# TECHNICAL SERVICE BULLETIN

## Oil Pan Leaking

**25-2395**

This bulletin supersedes 24-2345. Reason for update: update the Service Procedure.

Figure 1

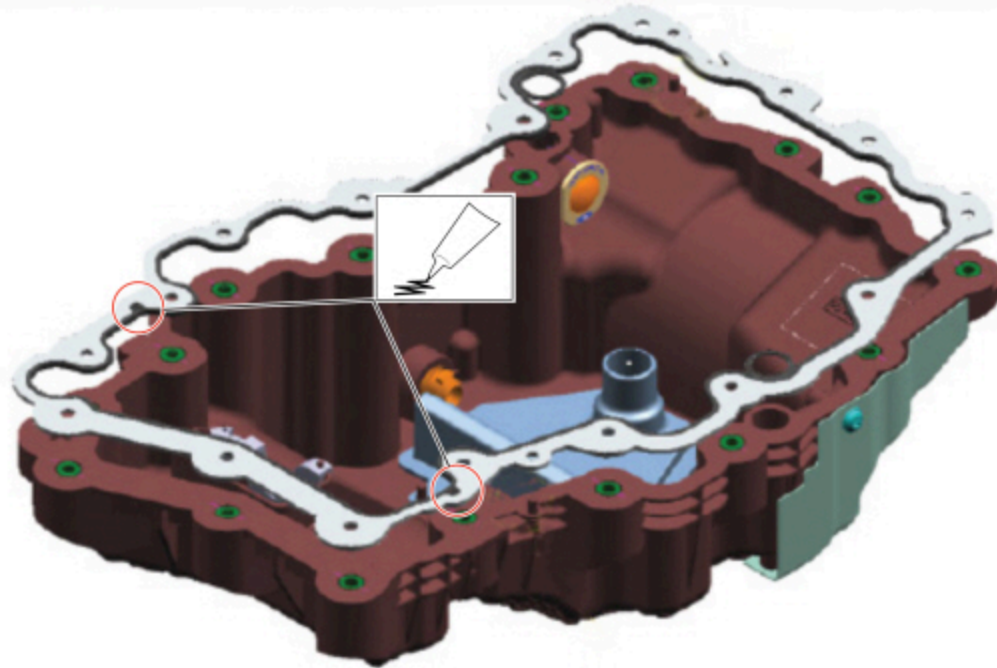
1. Remove and discard the oil pan and oil pump seal. Refer to WSM, Section 303-01, Removal and Installation > Oil Pan.
2. Clean and prepare the engine sealing surface. Refer to WSM, Section 303-00 > General Procedures.
3. Install a new oil pump seal. Refer to WSM, Section 303-01 > Removal and Installation > Oil Pan.
4. Verify the correct orientation of the new carrier gasket and install the new oil pan and oil pan gasket. Refer to the WSM, Section 303-01 > Removal and Installation > Oil Pan.
  - (1). Apply 18 mm of Motorcraft® High Performance Engine RTV Silicone at the T-joints, where the ladder frame meets the front cover (Figure 1). The new installed oil pan does not require the use of Motorcraft® High

Performance Engine RTV Silicone in any other location

**NOTE: The new oil pan design requires a carrier gasket, which differs from the previous design. The previous design required RTV to fully seal the entire oil pan.**
